PRE-APPLICATION CONFERENCE NOTES

Discount Tire
File No. PLZ-25-0129

Date	Application submitted: October 30, 2025 Pre-application conference: December 9, 2025
Proposal	Pre-application conference to develop a single-story 7,320 sq ft tire service center within Ridgefield Gateway with full site improvements.
Location	5824 Pioneer St / Ridgefield, WA 98642. Assessor's PIN 986067891, RIDGEFIELD GATEWAY SP4-411 LOT 5
Property Owner(s)	Taz Khan – Ridgefield Gate Partners, LLC PO Box 452 / Camas, WA 98607 Contact: 512-779-4999, tkhanusa@gmail.com
Applicant	George Nacsá – Halle Properties 20225 N Scottsdale Rd / Scottsdale, AZ 95255 Contact: 480.416.3178, George.nacsá@discounttire.com
Applicant's Representative	Charlie Severs, PE – JSA Civil, LLC 111 Tumwater Blvd SE, Suite B203 / Tumwater, WA 98501 Contact: 360.515.9600, Charlie.severs@jsa-civil.com
Zoning	Commercial Regional Business (CRB)
Review Type	Pre-application conference for Basic Site Plan
Potential Issues	Commercial Regional Business (CRB) development standards, landscaping, access and traffic impacts.

PRE-APP SITE PLAN

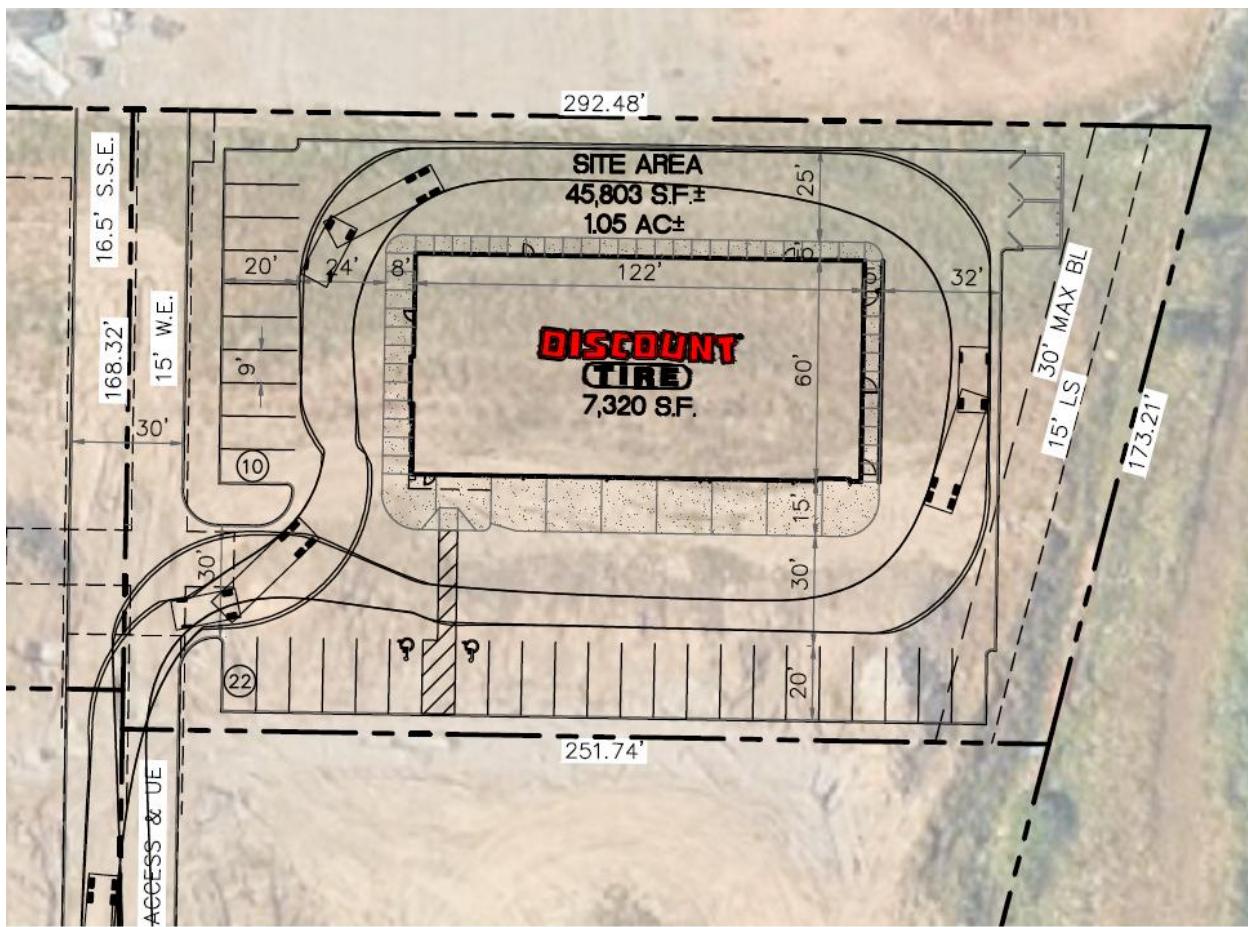
Comment: A pedestrian connection will need to be shown from the western parking stalls to the building. A connection will also need to be made to Pioneer St. In addition, the applicant will need to show how the connections will differentiate between the parking lot surfaces and crossings.

Comment: No common areas were shown on the preliminary plan. Common areas and their amenities must be shown on the site plan in order to receive technically complete.

Comment: The trash enclosures are proposed in an area of the site not visible from the public right-of-way. On the preliminary plan, the applicant will need to show screening and loading areas. The trash enclosures must be covered and the materials must use similar materials as the main structure.

Comment: The prominent facades would be the southern and the western elevations. Neither elevations appears to meet the requirement. A suggestion is adding windows to the roll up doors as other applicants have done with similar uses. Provide calculations showing that this standard is met.

Comment: It appears that concrete blocks are being used as the primary material; this is prohibited. 50% of the building material must be from the list above. Provide color elevations with a materials list and color palette shown.

Comment: In order to receive technically complete, color elevations with a materials list and color palette shall be provided. The black metal siding and the bright red shown on the preliminary drawings would not be accepted.
